ADDENDUM #4

Project: North Harford Elementary School Fuel Tank Removal

Bid #: CAG 25-3

Addendum No.4 is issued to clarify the burial depth of the (2) 1500-gallon propane tanks.

LP UNDERGROUND GAS STORAGE TNAK AND SERVICE DETAIL SCALE: NONE

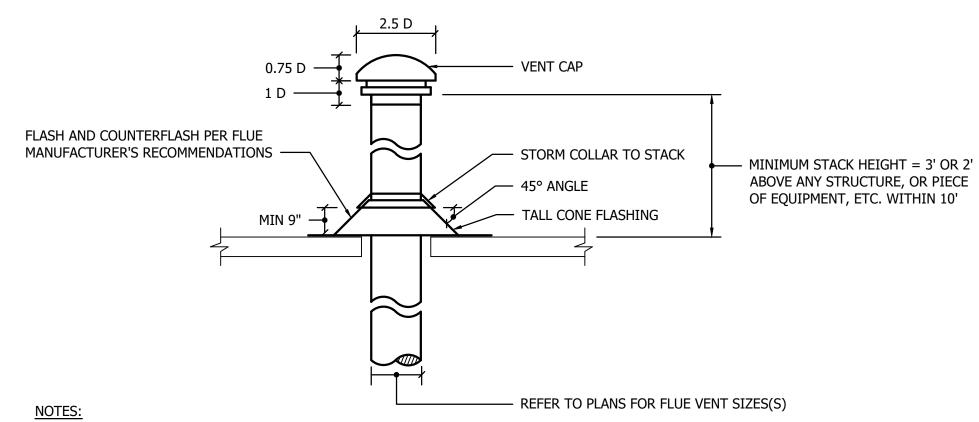
• The tanks shall be provided with a minimum cover of 18" as recommended by propane tank manufacturer. Updated sheet MP-701 is attached.
